APPLICATION NO.	FILING DATE	FIRST NAMED INVENTOR	ATTORNEY DOCKET NO.	CONFIRMATION NO.
10/738,364	12/17/2003	Theodore B. Mulle	2066/U	8555
47545	7590	01/08/2007	EXAMINER	
STEVEN A. GARNER, ESQ. CONAIR CORPORATION ONE CUMMINGS POINT ROAD STAMFORD, CT 06902			FRANCIS, FAYE	
			ART UNIT	PAPER NUMBER
			3725	
SHORTENED STATUTORY PERIOD OF RESPONSE		MAIL DATE	DELIVERY MODE	
3 MONTHS		01/08/2007	PAPER

Office Action Summary	Application No.	Applicant(s)
	10/738,364	MULLE ET AL.
	Examiner Faye Francis	Art Unit 3725

DETAILED ACTION

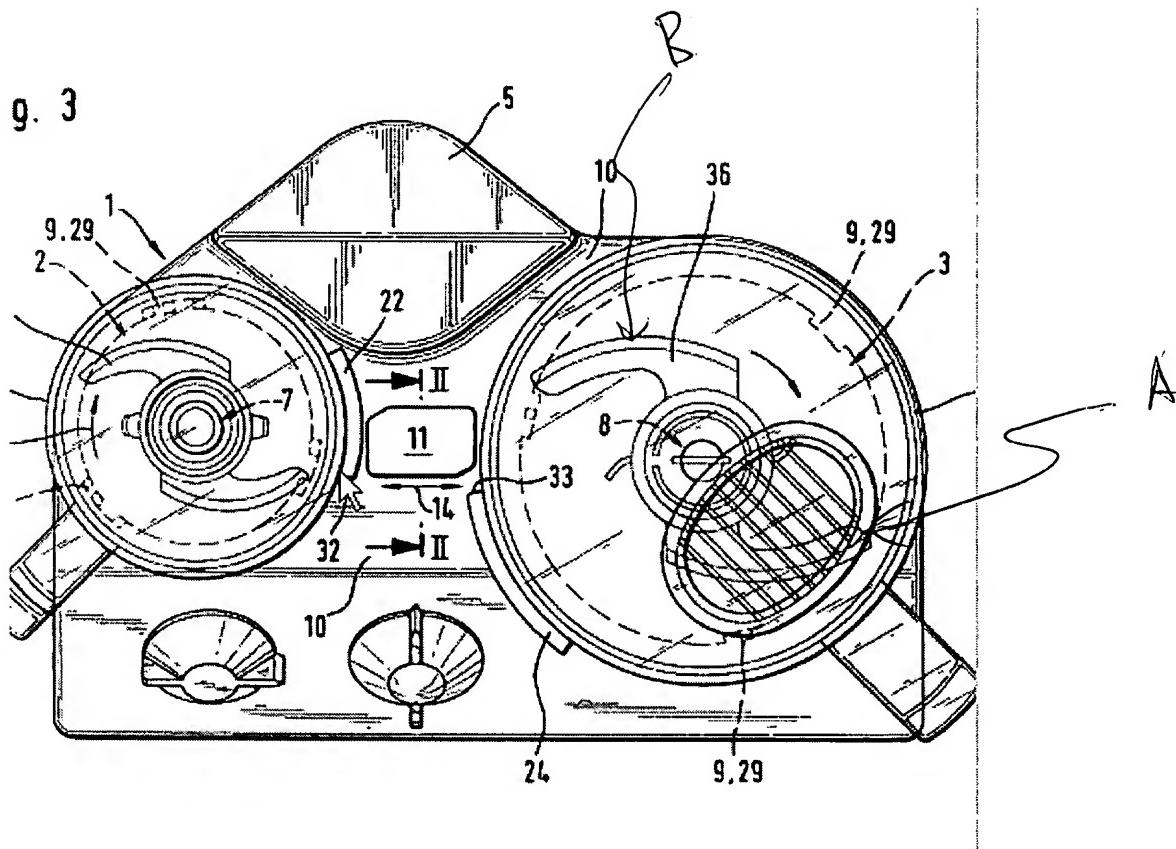
Borger discloses in Figs 1-5 (also see Figure below wherein the letters A-B have been added by the examiner), a cover assembly for food processing appliance comprising: a cover for cooperating with a container [housing 5, base 1 and bowl 6], the container cooperating with an operating base [base 1 and mount 3], the cover having an upper side with a predefined ingress area A, the operating base having a rotating tool

36 with a center of rotation [spindle 8] and a peripheral impact region B and the peripheral impact region being radially distanced from the center of rotation. Also, Brady discloses wherein the ingress area overlies at least a substantial portion of an outermost portion of the peripheral impact region relative to the center of rotation and wherein the ingress area does not overlap the center of rotation [see the Figure below] when the cover operatively connected to the container, the container is operatively connected the operating base and the ingress area is shaped so as to overlay at least a distal end of the impact region [see the Figure below].

Borger may not disclose the ingress area has a cross-sectional area substantially equal to half that of a lower side of the cover.

Either Doggett or Williams or Breeden or Plavcan et al teaches that providing a food processor with an enlarged ingress area having a cross-sectional area substantially equal to half that of a lower side of the cover is conventional. It would have been obvious to one of ordinary skill in the art at the time the invention was made, in view of either Doggett or Williams or Breeden or Plavcan et al to provide the device of Borger with an enlarged ingress area in order to accommodate the processing of relatively large food items. Additionally, it would have been obvious to further provide the device of Borger with an accessory in order to push the material down the feed tube.
